GOVERNMENT OF THE DISTRICT OF COLUMBIA  
OFFICE OF PLANNING

**MEMORANDUM**

**SUBJECT:** Final Report, Zoning Commission Case No.03-12G and 03-13G  
- Application by Capper/Carrollsborg Venture LLC and the District of Columbia Housing Authority (DCHA)  
- Request for Approval of 2<sup>nd</sup> Stage Hope VI PUD for Squares 882 and 769

**DATE:** March 9, 2009

**Figure 3: Square 882 Proposals**

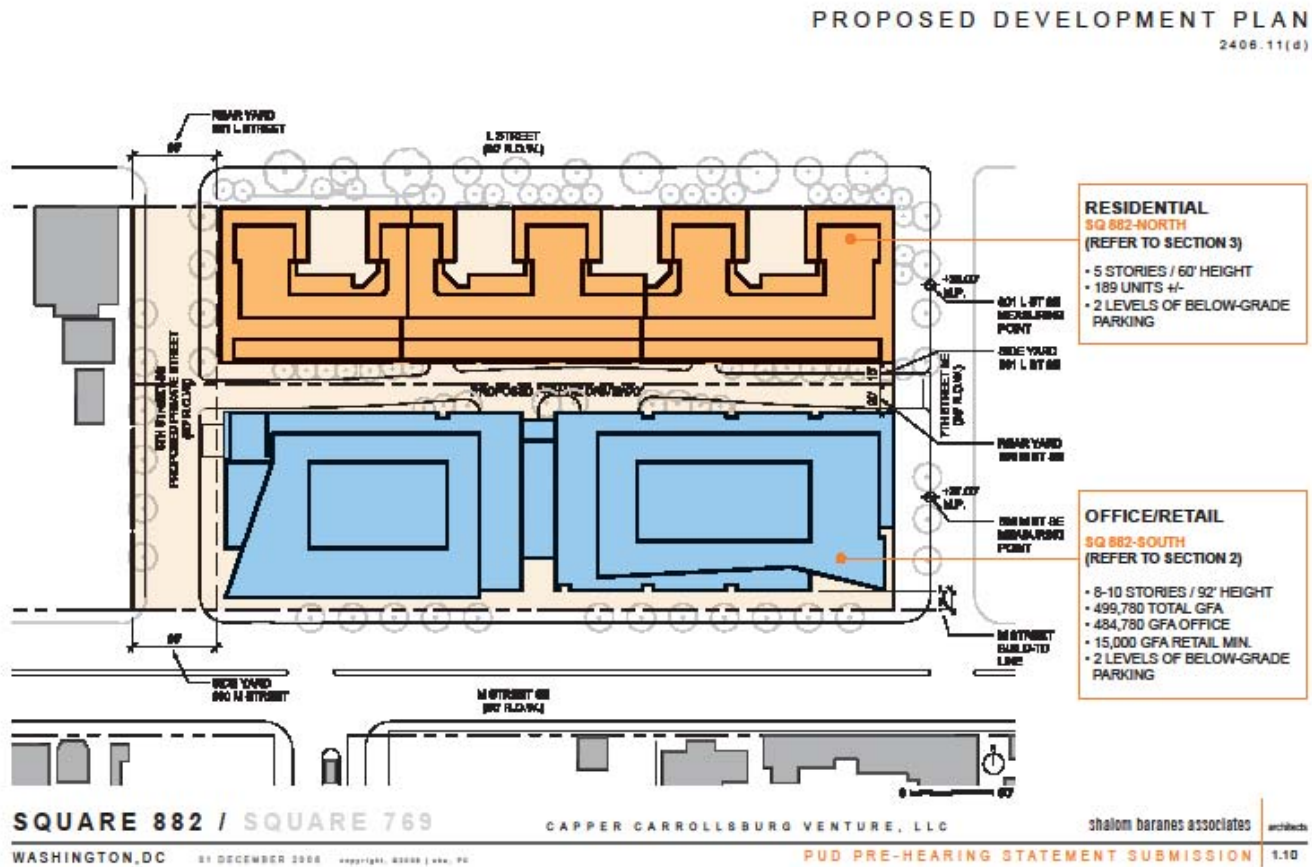
The office building would be two feet (2.2%) higher and 3,780 square feet (1%) larger than was approved in Order No. 03-12 / 03-13. It would contain at least 15,000 square feet of ground floor retail space and approximately 484,000 square feet of office space. It would have frontage on three sides and share a private alley with the residential development to the north. Loading would be off the alley. Parking would be accessed from the private 6<sup>th</sup> Street on the west and from the eastern side of the private alley behind the building. The building's mass would be broken into a nine story eastern wing and a ten story western wing with a three story retail, service and office section between the two sections. The roofline of the two wings would be at the same elevation point, but the number of stories would vary due to the grade's falling from east to west.

GSE: The requested 3,780 GSF increase would allow the applicant to give more shape to the building's mass without having to reduce the approved square footage. The revised design is less blocky and is more dynamic than the previous design. OP recommends the approval of the Second Stage square footage increase.

Height: The office building would determine and measure its zoning height from 7<sup>th</sup> Street, on which the eastern wing would have frontage. Measured from 7<sup>th</sup> Street, the proposed building would measure 92' and would require 2 feet of relief from Order 03-12/03-13. The building would appear taller towards its western end due to an approximately 24 foot decrease in ground elevation from east to west.

The Commission's original decision reduced the height of the proposed office building from the requested 110' permitted a PUD in the CR zone to the approved 90'. At that time, the applicant was not able to analyze the reduction's impact on floor-to-floor heights. The applicant now states that the two foot height increase in the Square 882 office building is intended to accommodate the required 14 foot-clear ground floor commercial spaces, and has demonstrated this on Sheet 2.21 of its pre-hearing drawings.

The Commission's height reduction was intended to: 1) ensure that building heights on M Street, SE stepped down closer to the Navy Yard gates at 8<sup>th</sup> Street; and 2) to reduce the marked difference between the height of the office building and the residences in Square 882. The requested 2.2% increase in building height would respect these objectives. Because of the requested 33% increase in the height of the residential building on the northern half of Square 882, the height differences between that building and a 2.2% higher office building would be less marked than under the currently approved plans. This is illustrated on sheet 2.10 of the pre-hearing plans.

OP recommends approval of the requested 2' height increase.

**Figure 4. Location of Proposed Apartment Building**

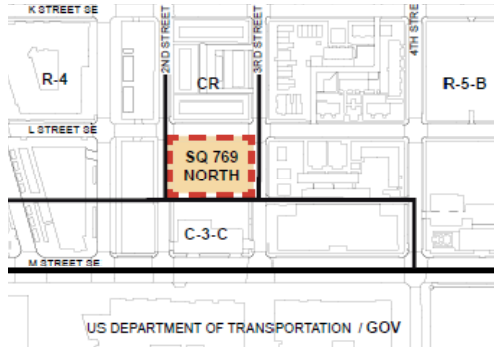
The residential building on the northern half of Square 769 would be 11,514 square feet larger and have 64 more units than previously approved. The increase number is due partially to its becoming rental units rather than the previously contemplated condominiums. The application proposes a 110 foot tall multi-family building with 177,330 GSF of residential space and 4,090 GSF of retail space. There would be 171 units, of which 20% (34) would be reserved for households earning no more than 60% of the AMI. All units would have access to 7,600 GSF of amenity space.

GSF: The requested increase from the Preliminary PUD would enable the applicant to construct more market rate units to help subsidize the construction of the 20% of the building that would be affordable units. Because the height would remain at the approved 110', and the façade would continue to be broken down into smaller elements, the additional GSF increase would likely have no increased visual impact from the approved building. OP recommends approval of the requested 7% increase in square footage.

Roof Structure: The applicant has requested roof structure setback relief for portions of the roof bordering the court that would open to L Street. The applicant has stated that the relief is needed to permit the roof structure to meet the service core needs of a "U" shaped building and for the western side of the roof structure to be set back adequately from the 2<sup>nd</sup> Street property line and the Canal Blocks Park. As shown on Sheet 4.11 the applicant is requesting setback relief of between 4'1" and 5' for the sculpted southern section of the courtyard. The applicant has not demonstrated how the mechanical penthouse functions make this relief necessary. It appears that there would be no need for relief if the courtyard and the penthouses were not sculpted to give more visual interest to the courtyard and the roof structure. If the walls were all at the line established at the narrowest part of the court, it appears that the building's functions would not be impaired, but the courtyard would become much more ordinary.

Loading: The applicant would provide the required 20' deep service delivery space, but is requesting relief from two loading requirements. It proposes to provide one 12' by 30' loading dock, which is 25 feet shorter than required, and 1 loading platform at 100 SF rather than the required 200 SF. The applicant has stated, but not demonstrated, that these loading facilities will be adequate to meet the building's needs. *DDOT has indicated that while it does not object to the request in concept, it must be able to review proposed arrangements for residential and retail trash storage and hauling before it can make a formal recommendation.* Therefore, OP recommends approval of the requested relief, subject to the submittal of a trash circulation and DDOT review of trash storage plan in relation to the requested loading dock and platform reductions.

CR Public Space Requirement: The proposed building is in the CR zone. 11DCMR Section 633.1 requires that an area equivalent to 10% of the total lot area (2,115 SF) be provided as public space at the ground level. The applicant is seeking complete relief from this requirement.
